August 16, 2020
 Cameron County
 2020 SECO LoanSTAR Program HVAC Upgrades #200802

ADDENDUM NO. 3

DATE: FEBRUARY 24, 2020.
 CHECKED BY: R.K./C.A.G.
 DRAWN BY: ETHOS
 PROJECT NO.: 18V20
 CAD FILE:
 SHEET:
ME2.1

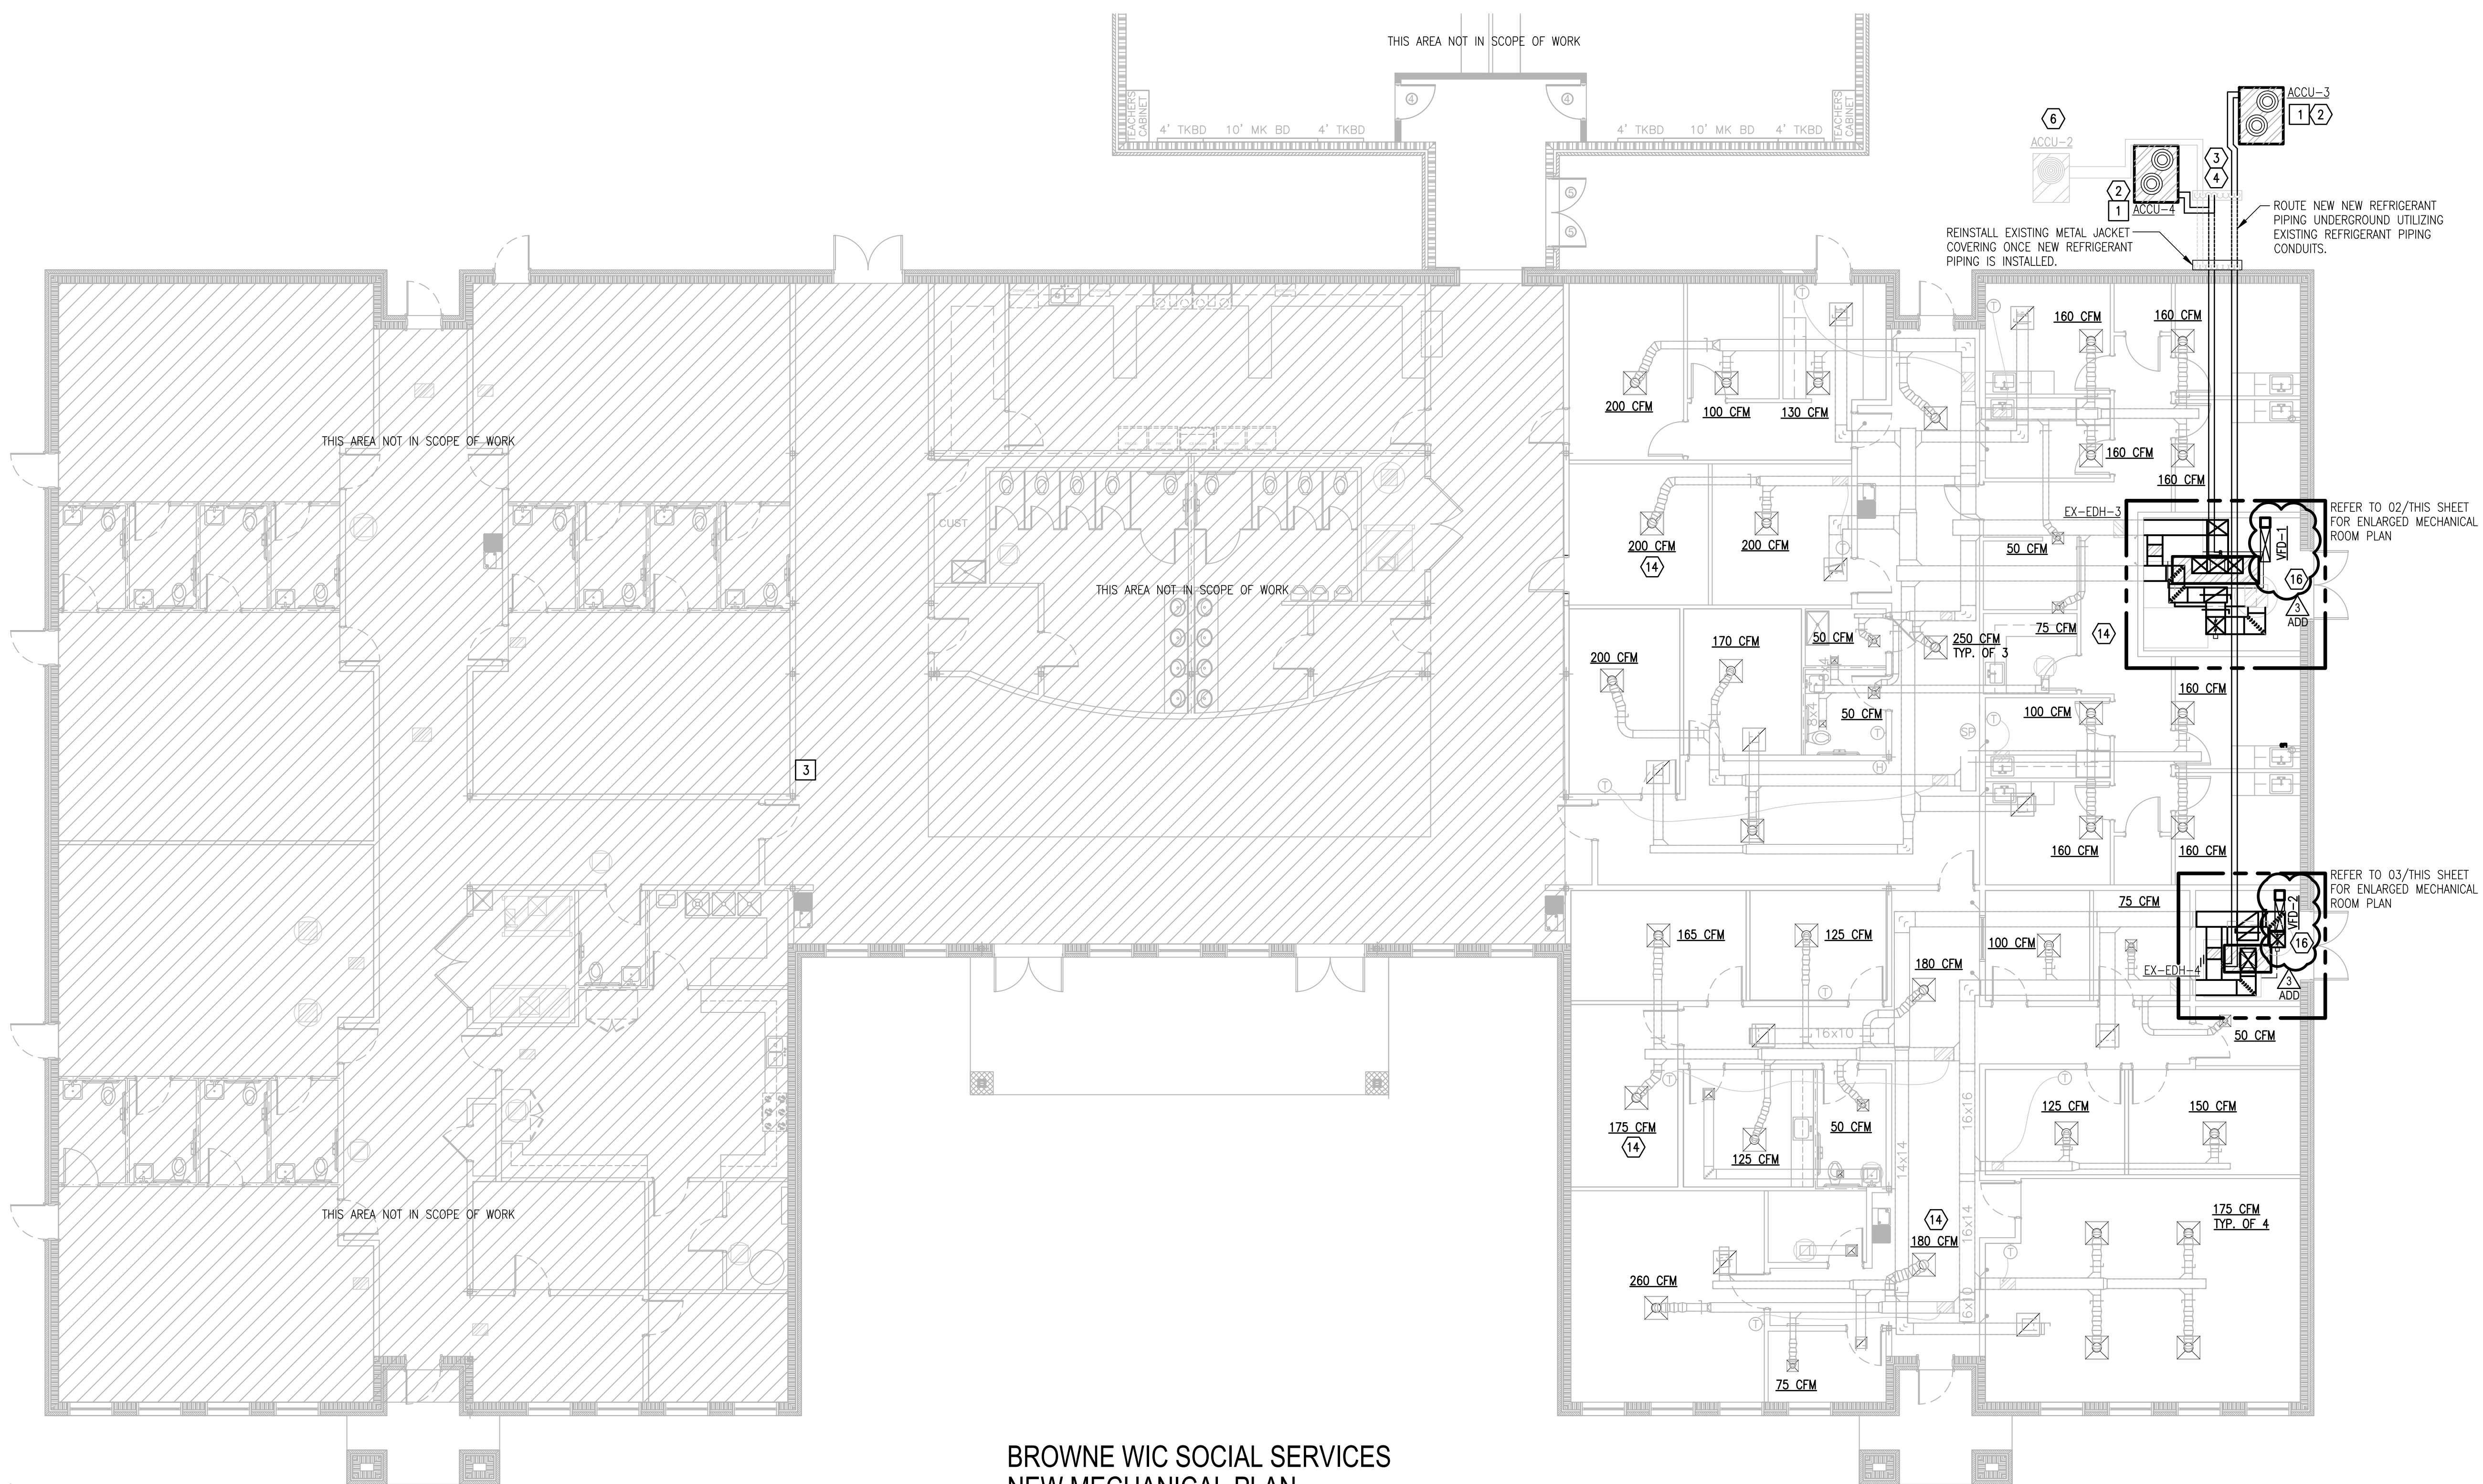
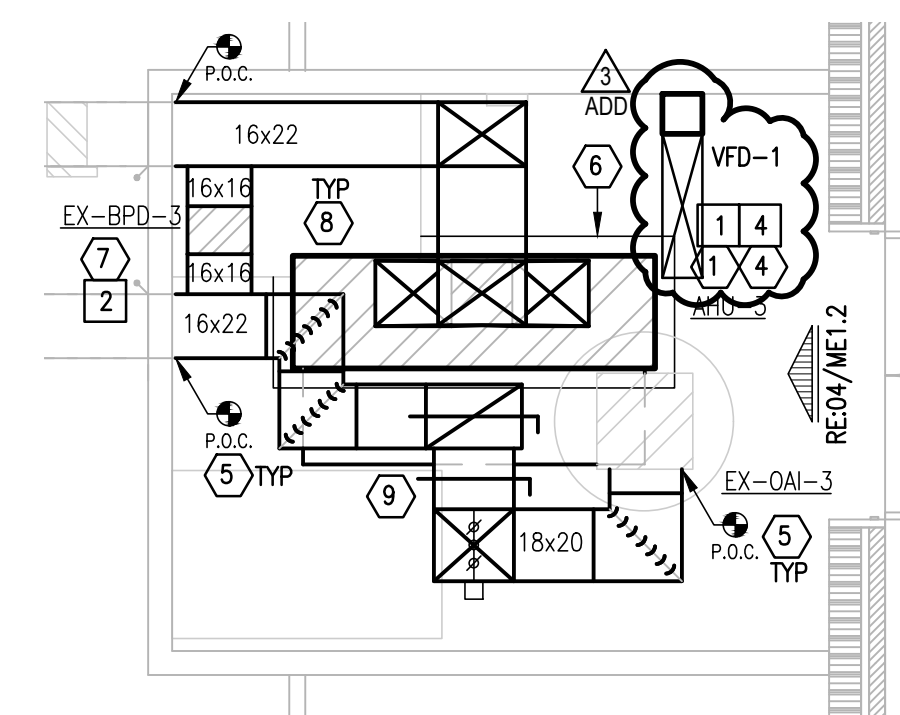
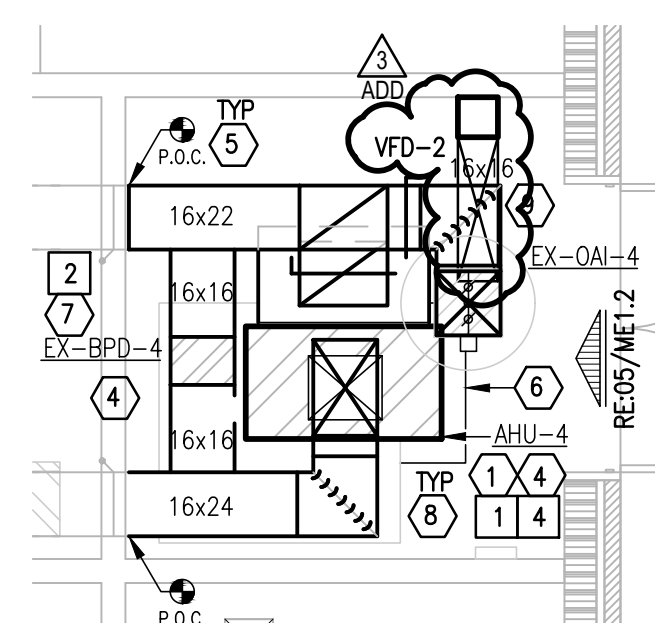
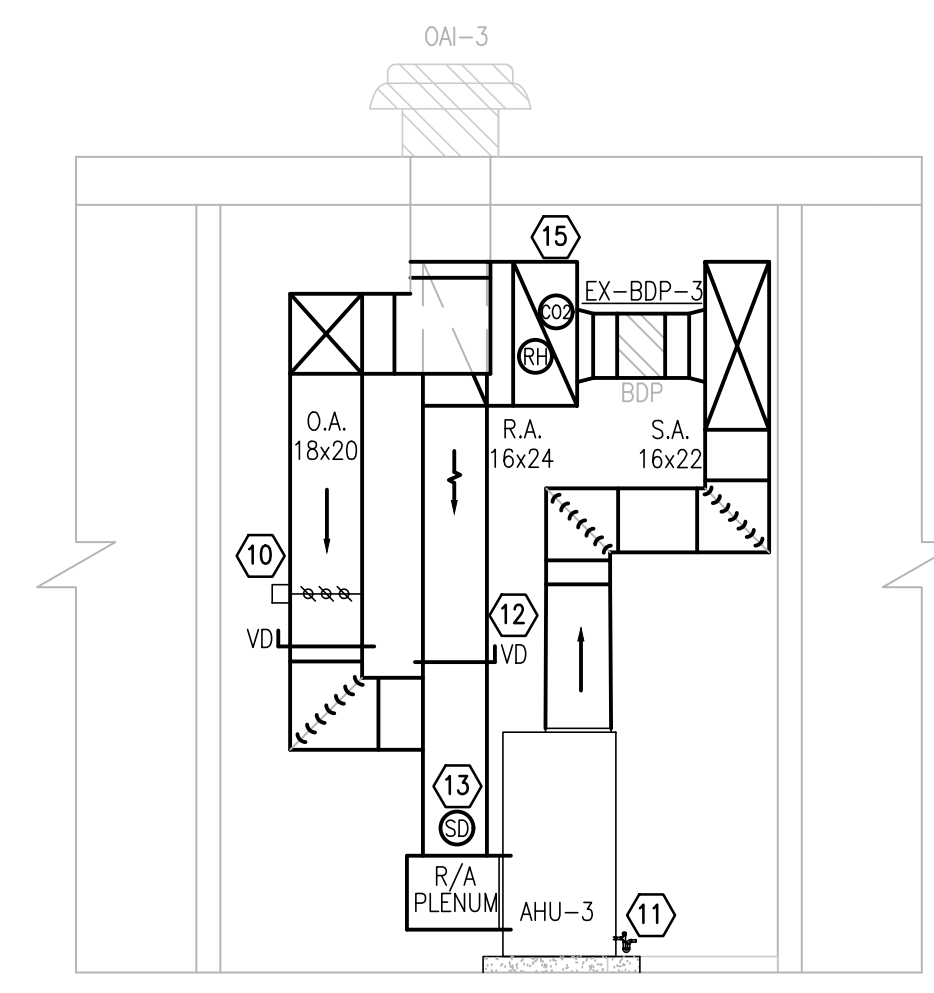
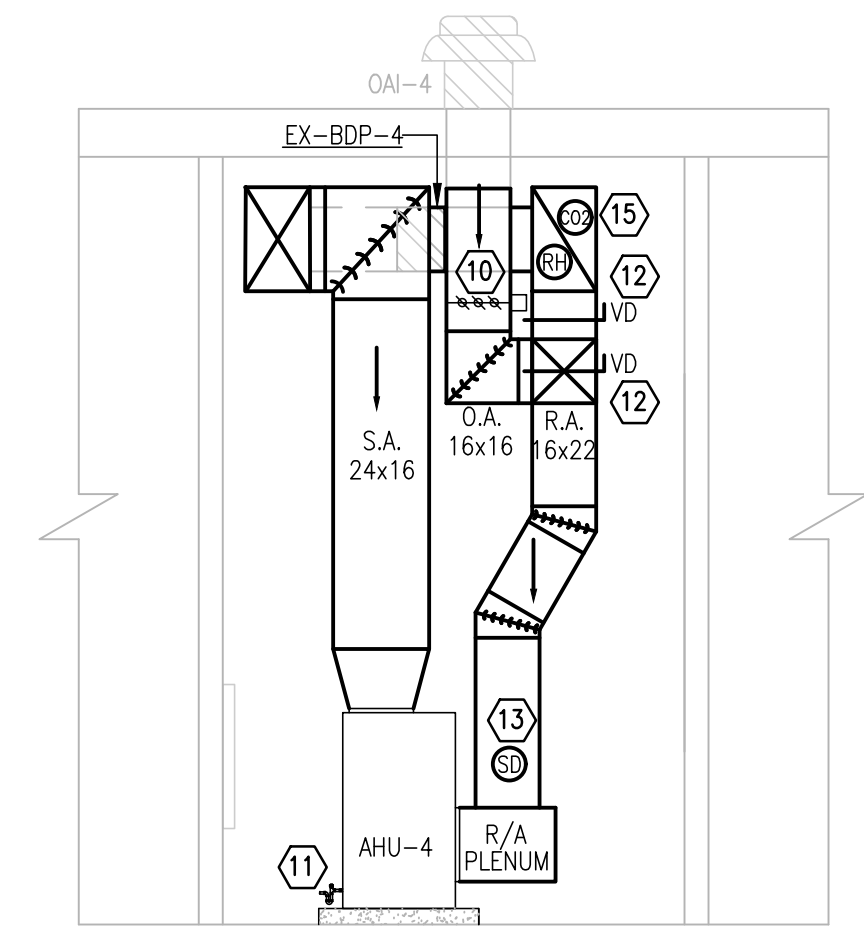
- i) Revised mechanical plan to accommodate VFDs for Browne Social Clinic. See attached sheet.

- RE-BALANCE EXISTING AIR DEVICES TO CFM SHOWN. (TYPICAL)
- PROVIDE DUCT MOUNTED RH & CO2 SENSOR. REFER TO SPECIFICATIONS FOR MORE INFORMATION.
- PROVIDE VFD PER SCHEDULE FOR MOUNTING INDOORS. MAINTAIN MINIMUM 3'-0" CLEARANCE IN FRONT OF VFD. (TYPICAL).

DATE: FEBRUARY 24, 2020
 CHECKED BY: R.K.C.A.G.
 DRAWN BY: ETHOS
 PROJECT NO.: 18V20
 CAD FILE:
 SHEET: ME3.1

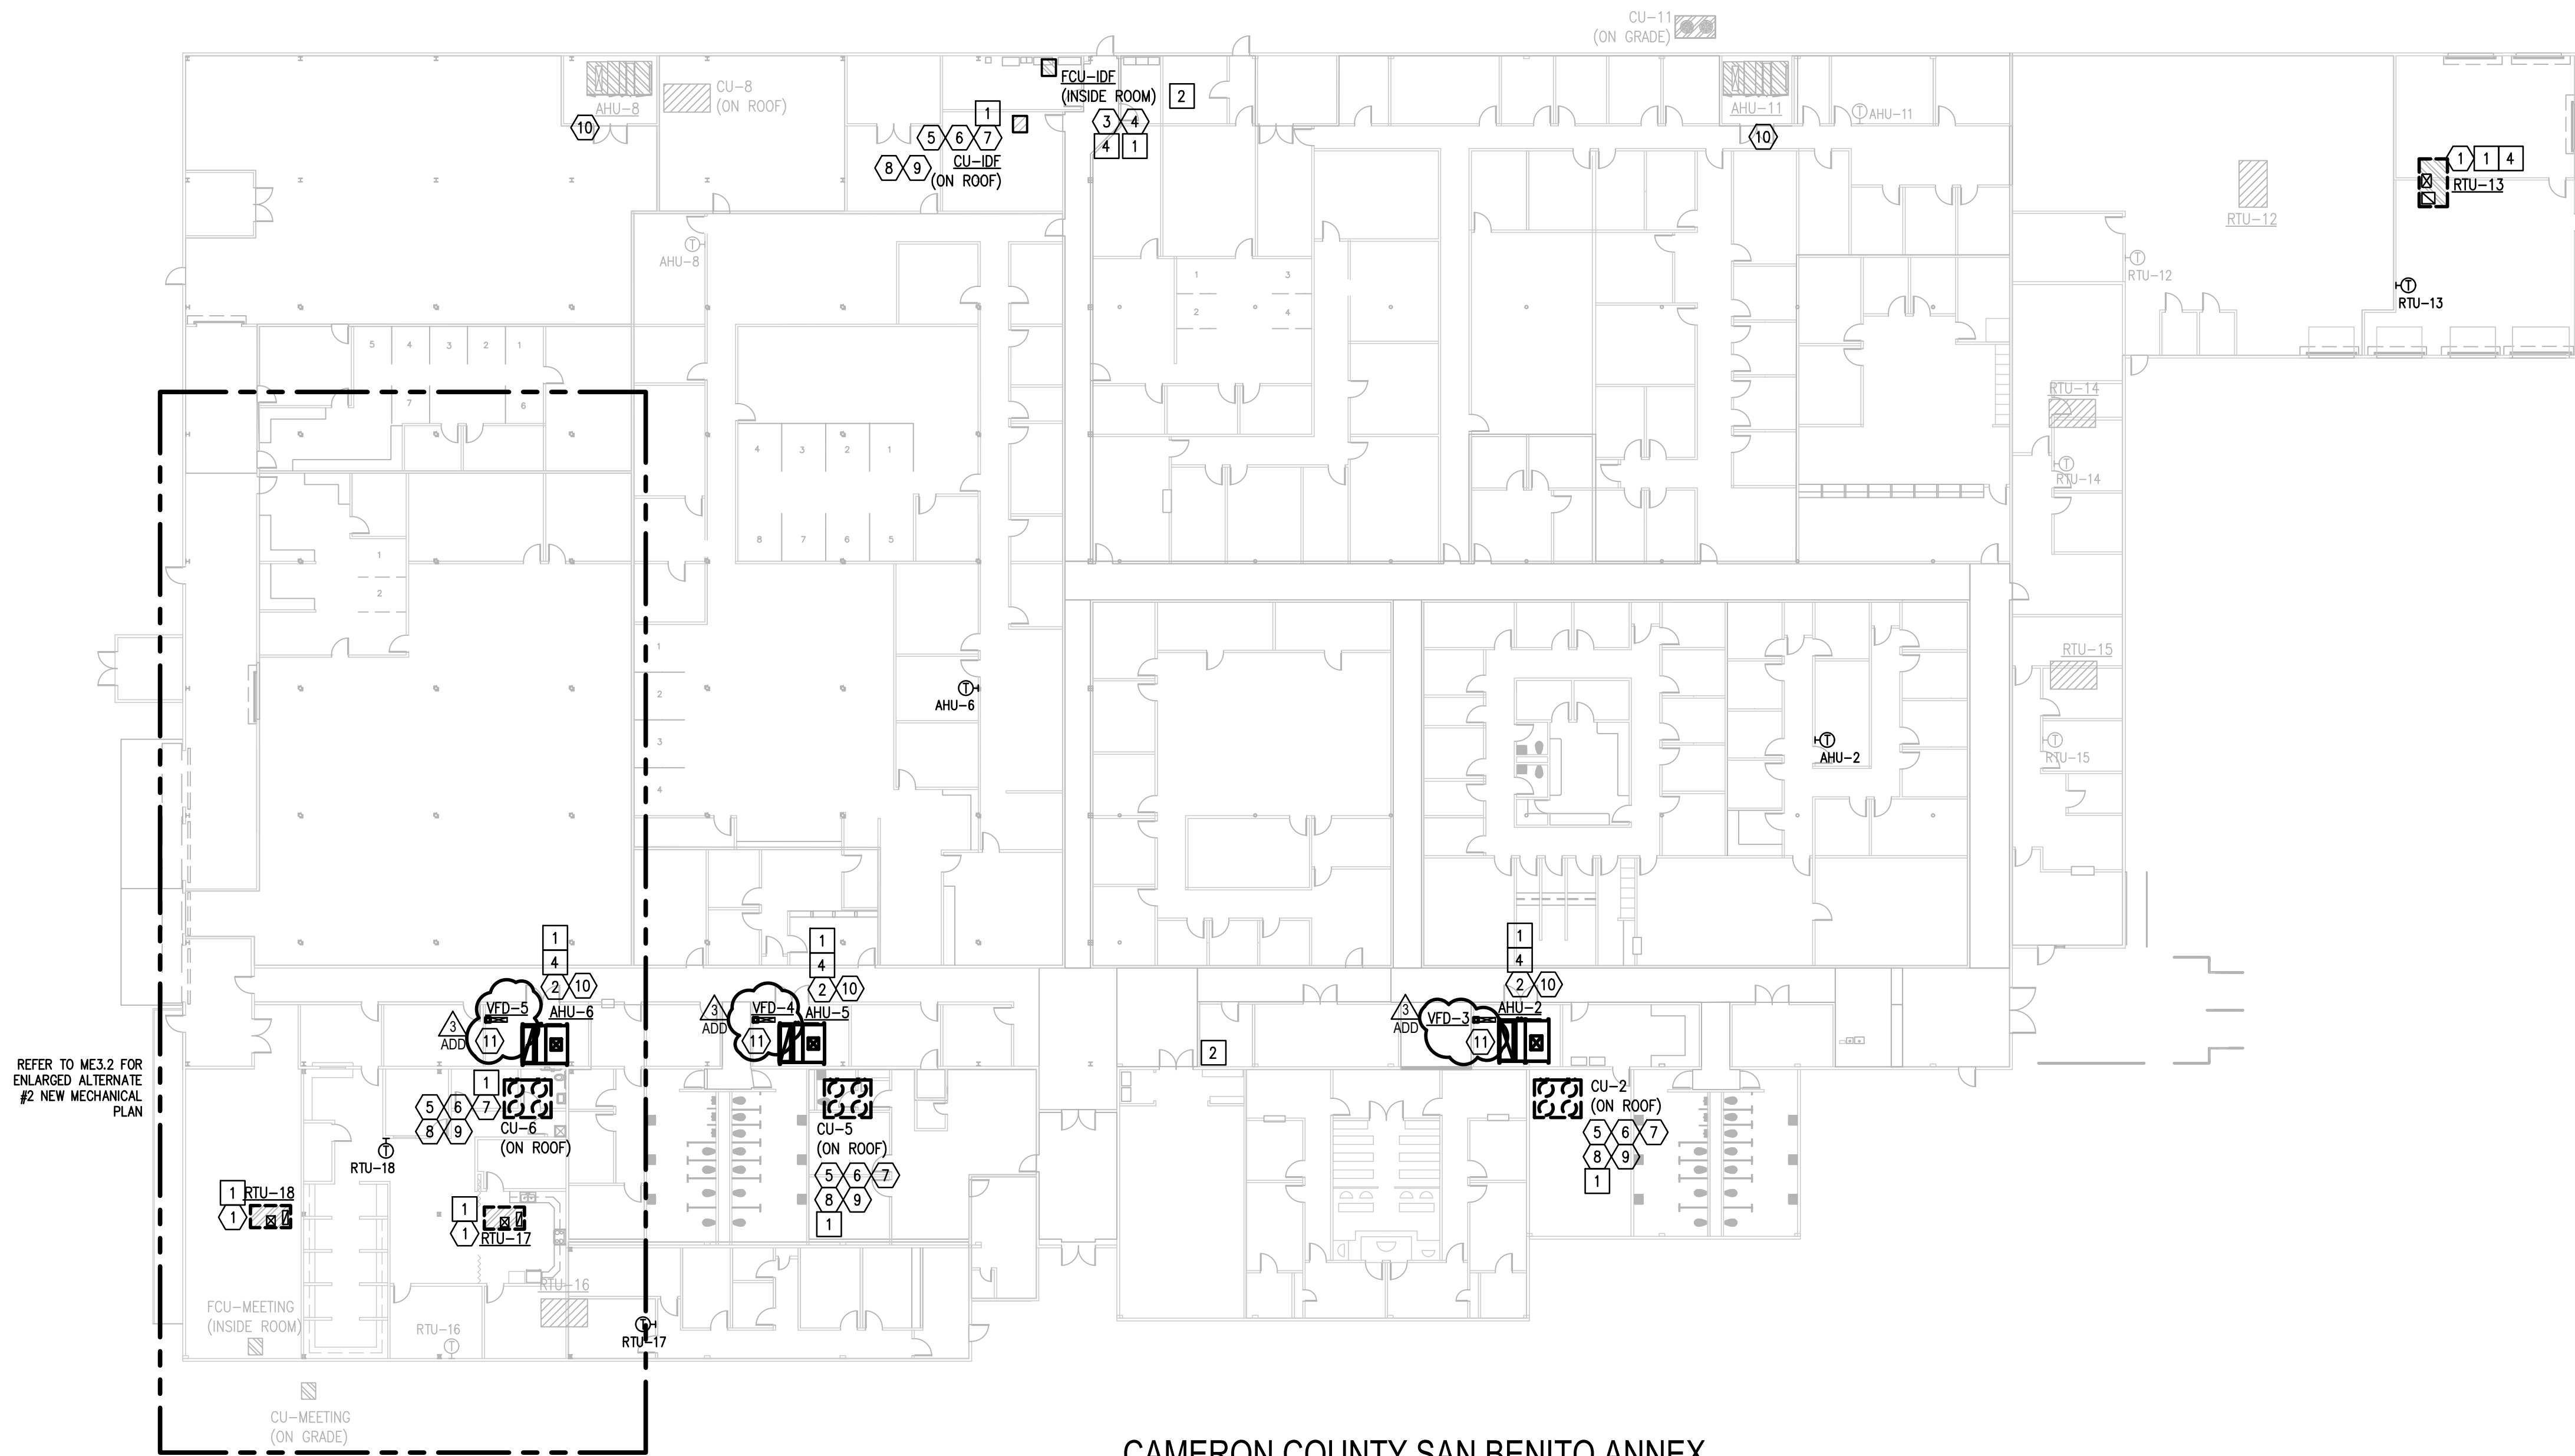
- i) Revised mechanical plan to accommodate VFDs for San Benito Annex. See attached sheet.

- PROVIDE VFD PER SCHEDULE FOR MOUNTING INDOORS. MAINTAIN MINIMUM 3'-0" CLEARANCE IN FRONT OF VFD. (TYPICAL).
